TOWN OF
EAST MONTPELIER, VERMONT
SELECTBOARD

Re: East Montpelier Access Permit #18-002

ACCESS (CURB CUT) APPLICATION

**Rauh -- 940 Murray Road
 East Montpelier**

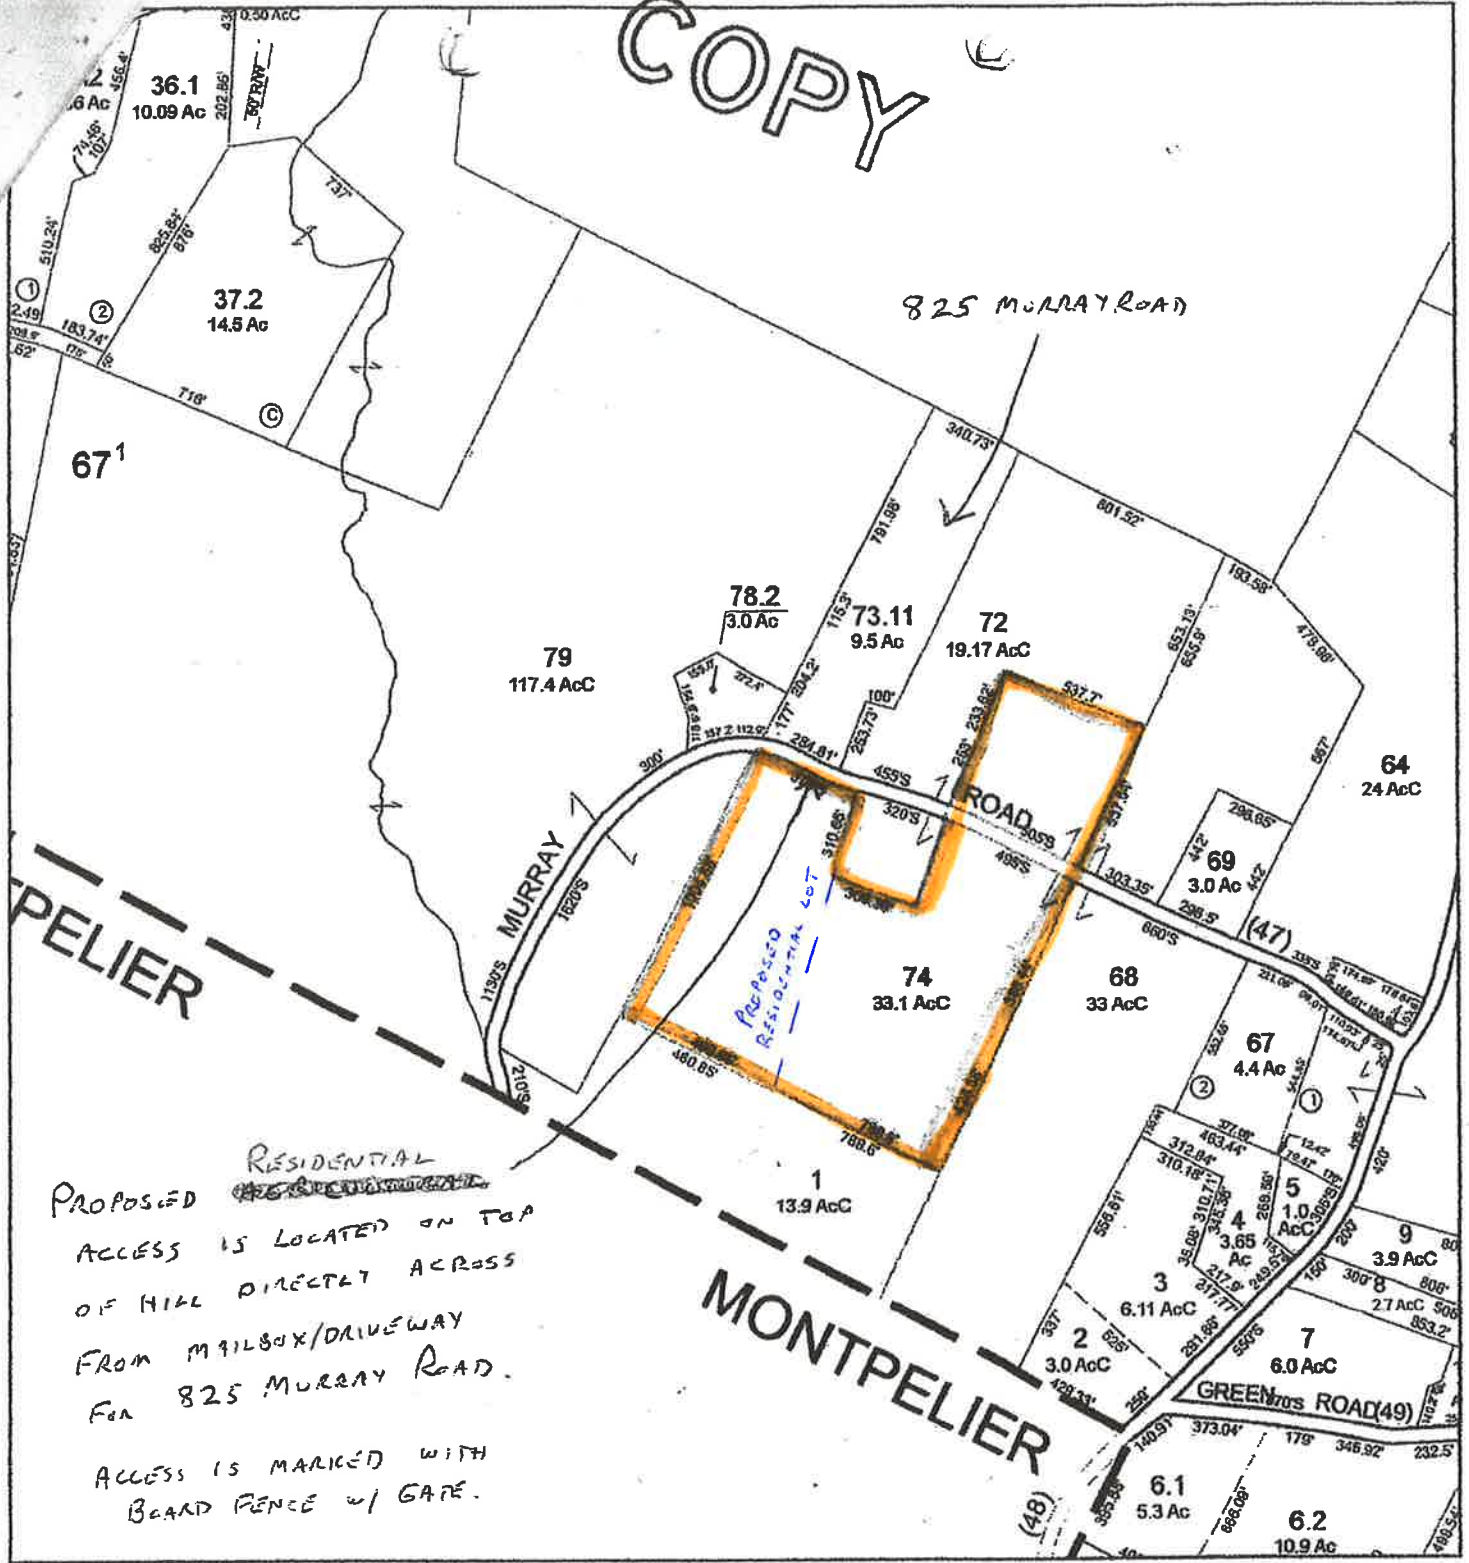
Proposed access meets applicable sight distance standards. Comments: Sight distance will be met after the removal of a tree.

I ask that the drive slope away from the road a minimum of 5 ft. There will be no need for a culvert.

Please see map that is attached,

Yellow dot- is a tree that needs to be removed

Blue area- slope away from Road a minimum of 5 ft
